BARRICK RESOURCES (USA), INC.

REF: Notice of Noncompliance: Water Balance Monitoring and Head Control Plan, Ground Water Quality Discharge Permit No. UGW450001.

DUMP LEACH 3 WATER BALANCE

Figure 1.

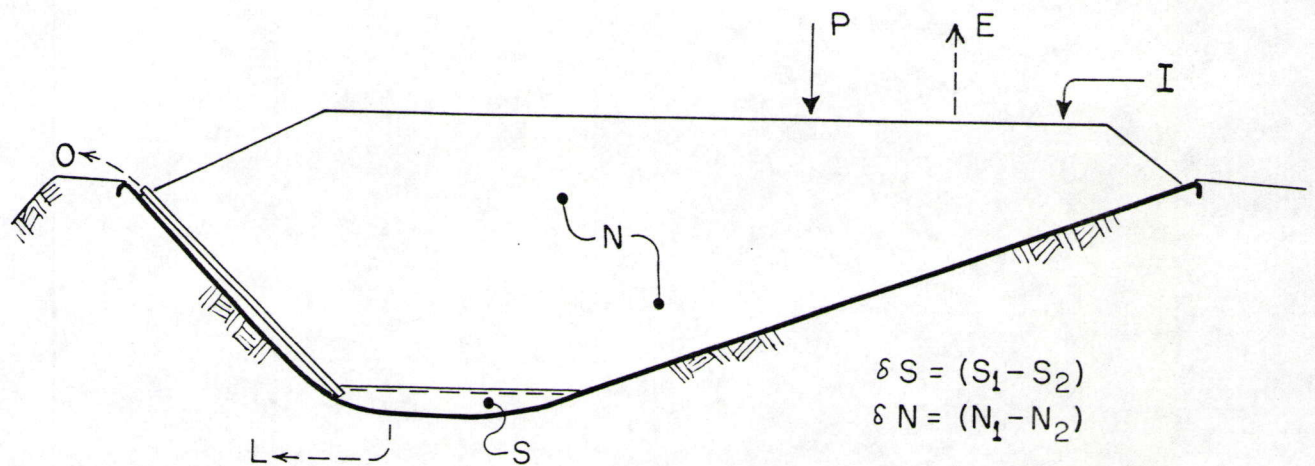
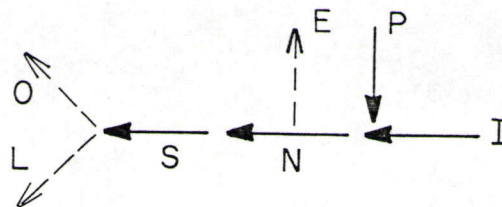
1. Utilized Porosity in the Vadose Zone (δN) - after careful review of the water balance equation presented for Dump 3 in Section 1.2.a of the plan and discussions with Barrick staff we have determined that two significant issues exist regarding δN :
 - a) No practical method to independently measure the utilized vadose zone porosity exists, with a reasonable degree of certainty for dump leach No. 3, and
 - b) Barrick's current practice is to set the water balance ratio of inflows to outflows equal to 1.0 and then back-calculate an appropriate value for δN .

This practice nullifies the purpose of water balance monitoring, in that the ratio is never allowed to deviate; δN is not independently measured; and that the equation represents two unknowns, δN and uncollected leakage. Consequently, an acceptable plan will include a water balance equation and an inflow/outflow ratio that ignores δN , allows for ratio deviation from 1.0, and provides for the independent measurements of all parameters. We recognize that this will result in an inflow/outflow ratio that will be greater than 1.0 even when leakage from the system may not exist. However, this should not pose a problem so long as an appropriate upper limit is established for monitoring. Barrick must also provide a justifiable value for this upper limit.

(b)

This approach is reasonable, as shown in the accompanying Fig. 1. The vadose zone functions in a surge capacity, with all inflows and outflows known. The logic diagram within Fig. 1 should clarify these relationships. Though not directly measured, the vadose zone flow can be resolved algebraically.

This practice does not nullify the purpose of water balance monitoring. The equation does not represent two unknowns, as the leakage is measured independently. The error analysis can indicate whether significant unmeasured leakage is occurring. Accounting for the vadose zone as a surge member is in fact the only means of achieving a reliable balance. It then becomes a prudent calculation in the operation and analysis of the system.

Any flow balance which ignores the vadose zone component is improper. Furthermore, the intent to evaluate such a balance on a daily basis also is compromised since the vadose zone serves the same role as a surge tank. Omission of a surge member within a flow network renders the network mathematically insoluble.

Barrick's approach is realistic and technically supportable. Barrick will continue to record all apparent flows in the manner described in the Water Balance Monitoring and Head Control Plan, or as amended by this letter.
